A.P.- 1338-1352 Congress Street

cc to: St. Patrick's Church & Rectory
17 Frances Street

General construction permit for erection of church and rectory at the above named location is issued herewith to contractor based on plans and specifications filed with application for permit, but subject to the following conditions:

In accordance with the latest communication, dated December 7, 1962, from the Department of Building Inspection of the City of Portland, we kindly request that you adhere in strict compliance with all the items stipulated therein.

ST. PATRICK'S CHURCH
 1348 CONGRESS ST.
 PORTLAND, ME.
 KITCHEN VENTILATION
 REVISED DRG'S 11/19/67
 BY
 JAMES A. McBRADY INC.
 169 FRONT STREET
 SOUTH PORTLAND, MAINE
 SHEET # 1

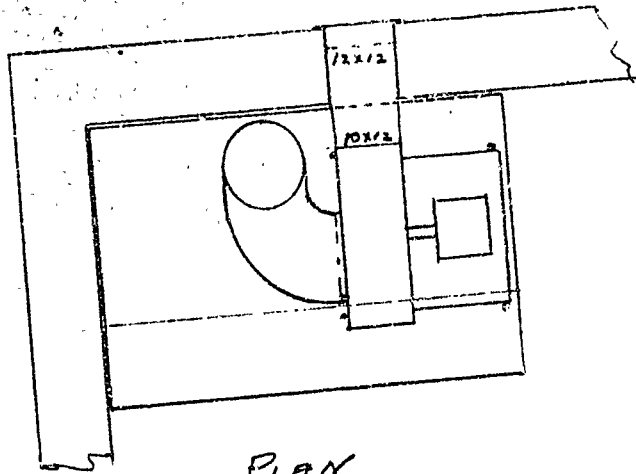
WINDOW SHOWN ON SKETCH DATED 1/5/67 WILL BE COMPLETELY REMOVED AND OPENING BRICKED UP.
 4-16" X 20" X 2" GREASE FILTERS WILL BE INCORPORATED IN HOOD.
 GREASE GUTTERS WILL BE BUILT INTO HOOD AS REQUIRED.
 SEAMS AND JOINTS WILL BE SOLDERED AS REQUIRED BY CODE. RANGE WILL BE SEALED TO WALLS AND FLOOR AS REQUIRED.
 FAN WILL BE MOUNTED WITH VIBRATION ISOLATORS.
 INTERIOR OF HOOD TO BE FREE OF ANY PROJECTIONS.
 HOOD WILL BE STAINLESS STEEL.
